METROPOLITAN GOVERNMENT OF NASHVILLE AND DAVIDSON COUNTY

STAFF RECOMMENDATION
1000 Woodland Street
March 17, 2021

Application: New Construction—Infill
District: Lockeland Springs-East End Neighborhood Conservation Zoning Overlay
Council District: 06
Base Zoning: MUL-A
Map and Parcel Number: 08309021200
Applicant: Dan Tansey, Architect
Project Lead: Sean Alexander, sean.alexander@nashville.gov

Figure 2: Woodland Street elevation showing the two proposed commercial infill buildings.

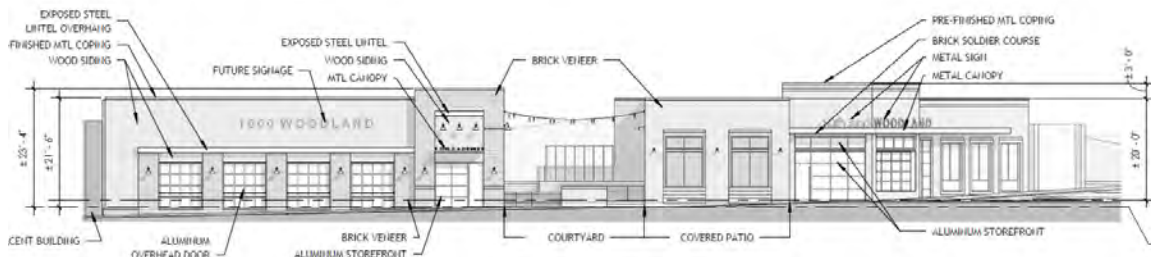
Height & Scale: The structure at the corner will have seventy-six feet (76') of frontage along South 10th Street, including eighteen feet (18') of screen wall at the southern end, and forty-five feet (45') of frontage along Woodland Street. The other building will have seventy-nine feet (79') of frontage along Woodland Street. There will be a twenty-eight foot (28') wide courtyard between the two buildings on Woodland Street. Both buildings will be constructed at the respective built-to lines of the two streets, comprising sixty-two percent (62%) of the frontage along South 10th Street and seventy-eight percent (78%) of the frontage on Woodland Street. This is consistent with the surrounding context, which comprises a one-story commercial strip on Woodland Street historically broken by an alley entrance, and detached buildings with access for parking at the rear on South 10th.

At its tallest point at the corner, the South 10th Street facade will be twenty-three feet (23') tall; the shortest portion of the building, the screen wall at the southern end, is fifteen feet (15') tall. The Woodland Street facade will be between twenty-one and twenty-four feet (24') tall, as the grade drops slightly down toward the east.

Staff finds the scale of the proposed infill is compatible with the surrounding historic context, and that it meets sections II.B.1 and II.B.2 of the design guidelines.

1 WOODLAND STREET ELEVATION

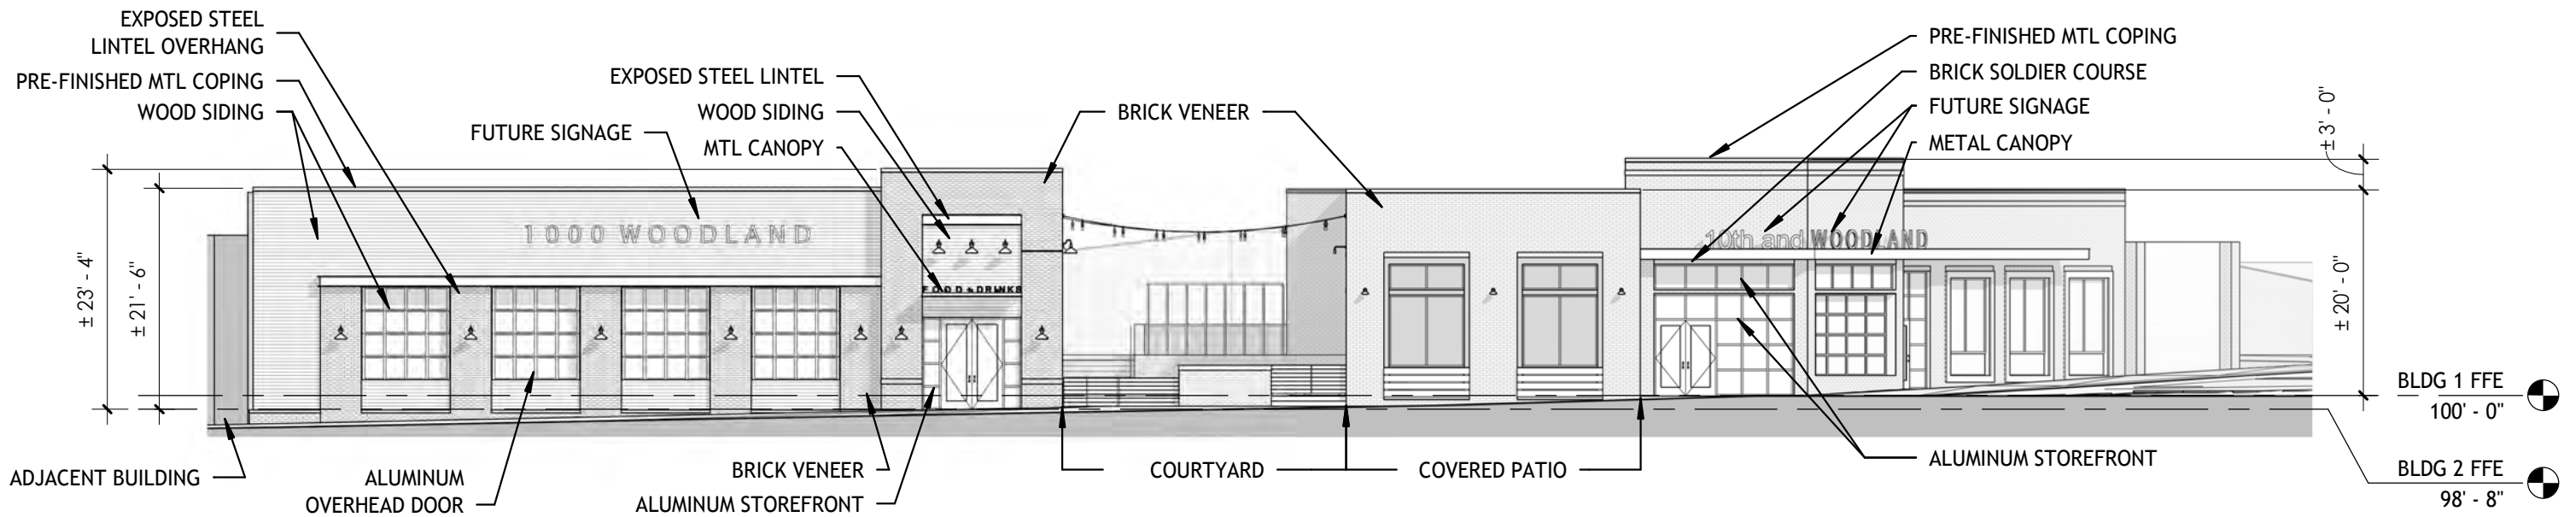
Proportion and Rhythm of Openings: The corner building will have five bays facing South 10th Street and three facing Woodland Street. These bays will have storefront-type windows and doors, with a combination of vertical and horizontal divisions, with fiber-cement bulkheads. Two of the Woodland Street bays will be recessed, creating a covered porch within the footprint of the building.

The plans indicate that four of the bays on the Woodland Street will have overhead doors, which will have aluminum frames and glass panels, above bulkheads with wood siding.

This type of door is more typical of a garage or vehicular-oriented building, whereas the historic buildings on Woodland Street are typically pedestrian-oriented. The Commission has not previously approved overhead doors on a primary façade. For example, 1105 Fatherland, a one-story, non-historic building recently requested overhead doors but revised their plan with a folding glass wall system. Overhead doors are also proposed on the courtyard elevations, beginning at the second bay from the front. Staff finds that the overhead doors are appropriate on the non-street facing elevations.

With the condition that the bays on the street-facing elevations not have overhead doors, Staff finds that the window proportion and rhythm of openings are generally compatible with the historic context and that the project will meet section II.B.7 of the design guidelines.
